A. **MOOSE BED RIDGE:** The request is to create two lots from Parcel 4, MSB Waiver Resolution #98-83, recorded at Book 991 & Page 927, to be known as **MOOSE BED RIDGE**, containing 26.16 acres +/- . The property is located south of W. Pinnocle Lane, north of W. Glenn Highway, and west of W. Gamway Drive (Tax ID #20N09E30A007); within the NE ¼ Section 30, Township 20 North, Range 09 East, Seward Meridian, Alaska. In the Glacier View Community Council and in Assembly District #7. *(Petitioner/Owner: Hanson Land Solutions, Staff: Matthew Goddard, Case #2025-183)*

STAFF REVIEW AND RECOMMENDATIONS
PUBLIC HEARING
JANUARY 28, 2026

ABBREVIATED PLAT: MOOSE BED RIDGE

REVIEWED BY: MATTHEW GODDARD CASE #: 2025-183

MONUMENT SUMMARY SHEET

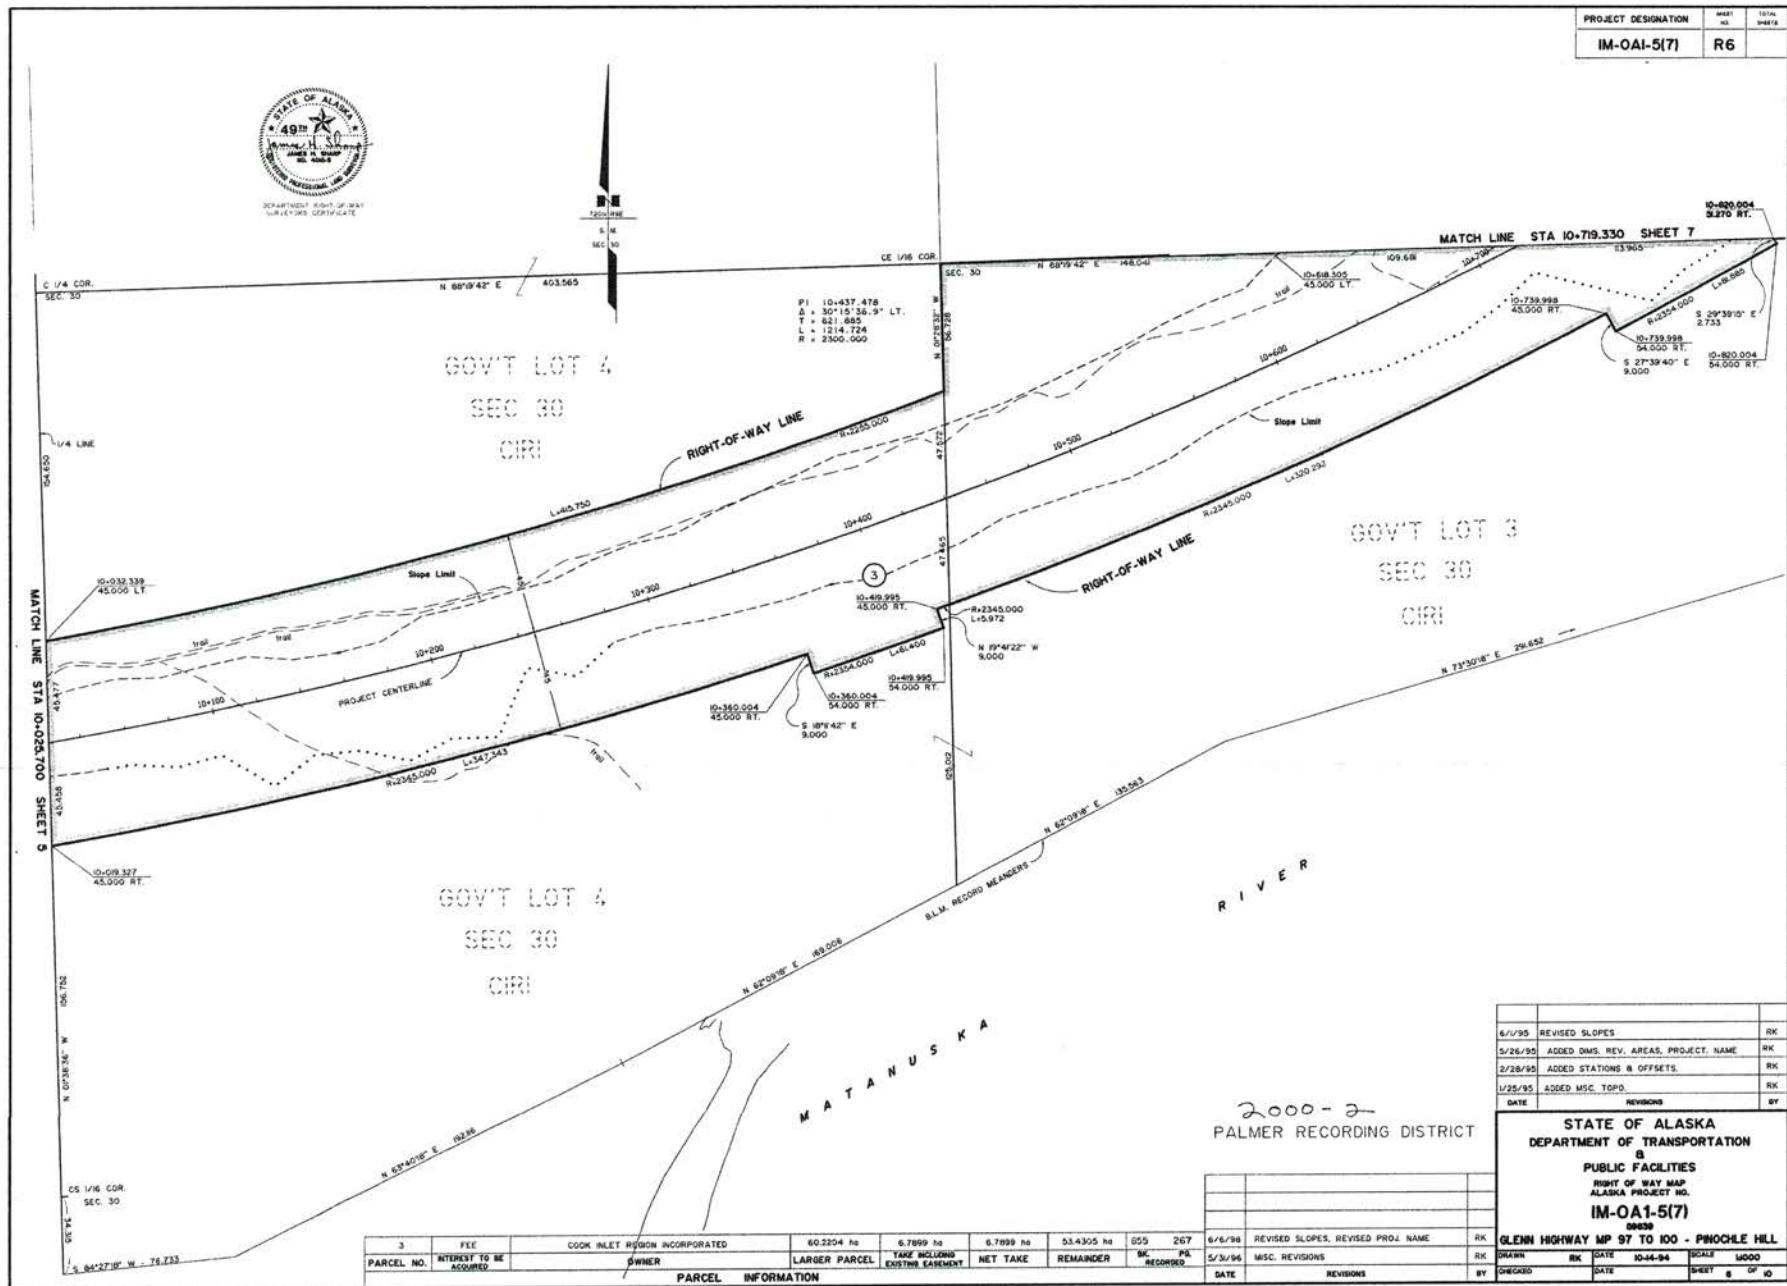
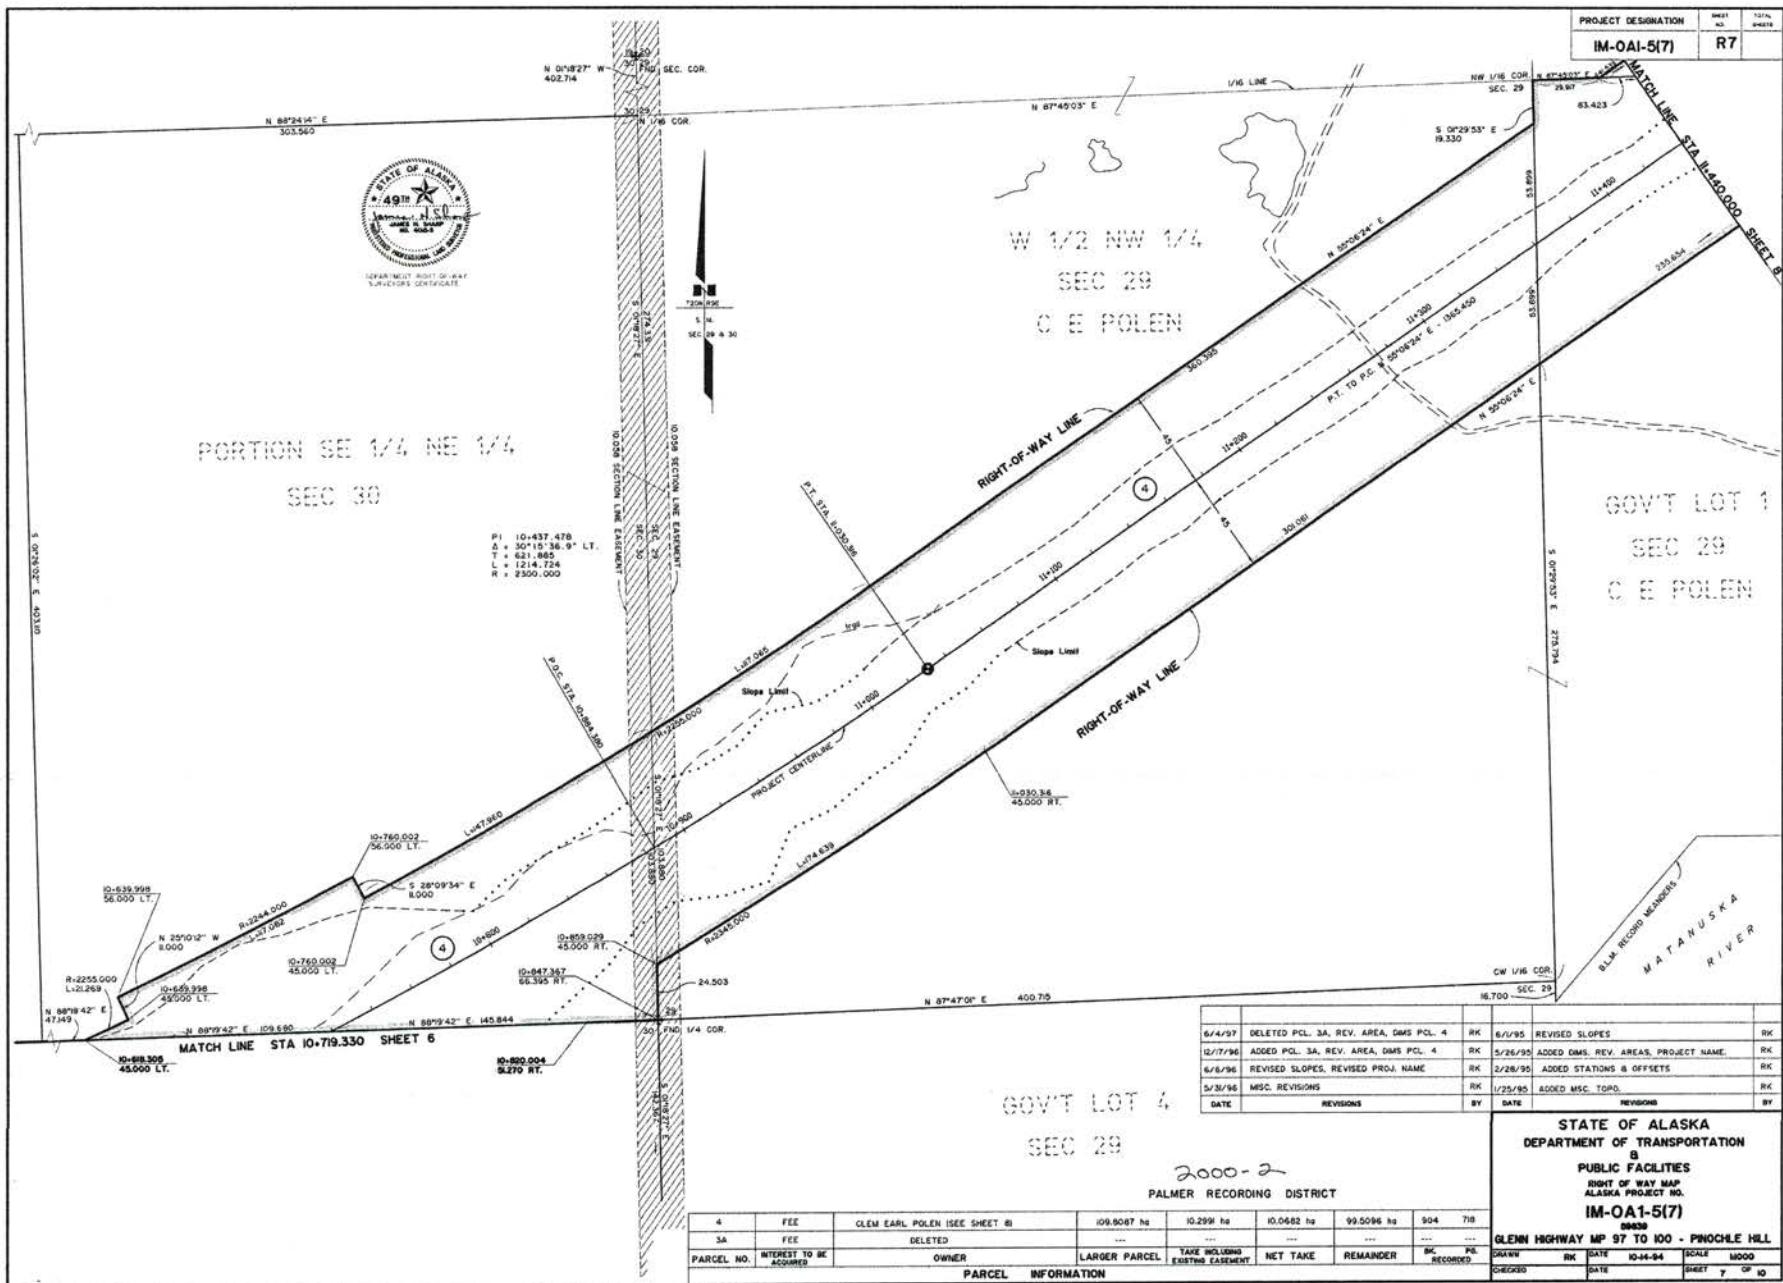
*This agenda plat does not match the ROW shown on 2000-2. Why is there a ~5' shift?

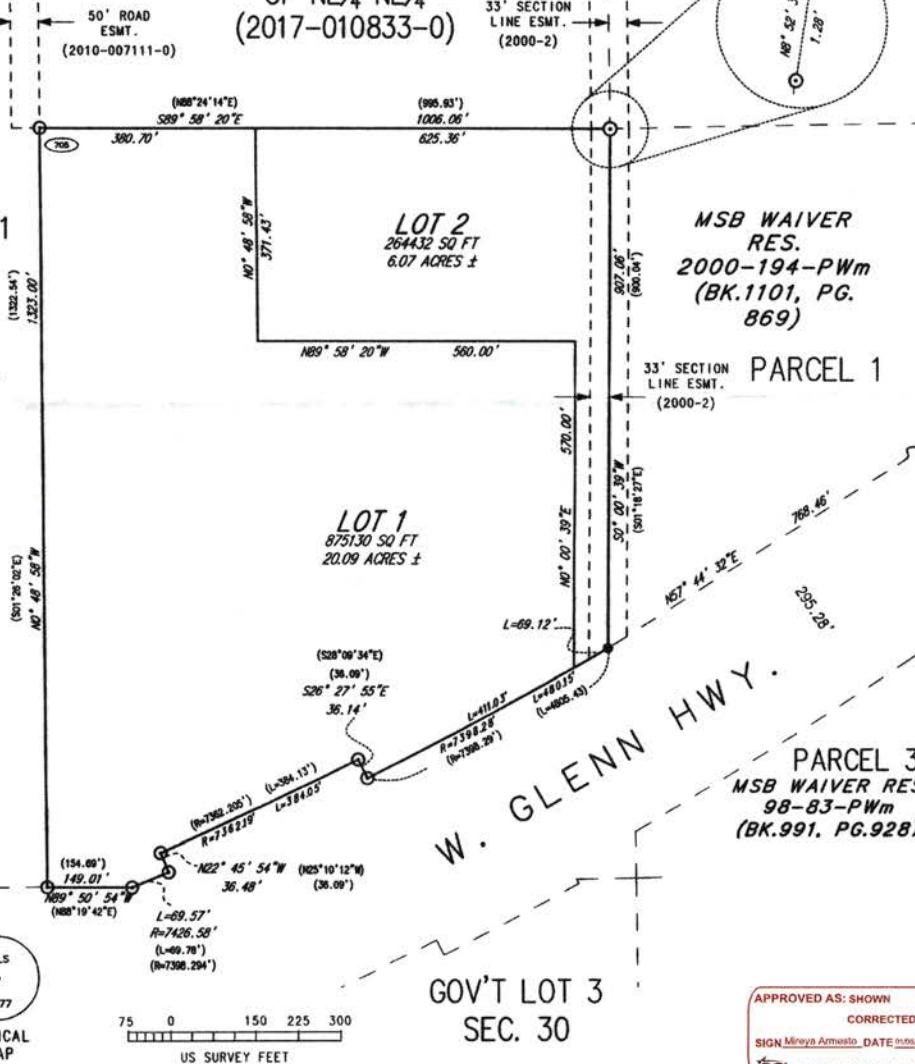
*It is not clear what is being set vs. what was found. According to this agenda plat all corners were found?

*Which corner in the NE is actually being held?

*Hanson surveyed the corner to the east shown here as a tie in 2024 as well as the centerline monuments per Plat 2024-101. This agenda plat should be tied into, and show the centerline monuments also.

*Please do not cite the source of the SLE as plat 2000-2. Instead cite the Statutes shown in the SLE determination document.

*Typo in record Length near the found rebar. (not 4805.43')

Platting staff notes that if this case is approved, all detailed information on the agenda plat will be reviewed and corrected as needed during the final review process.
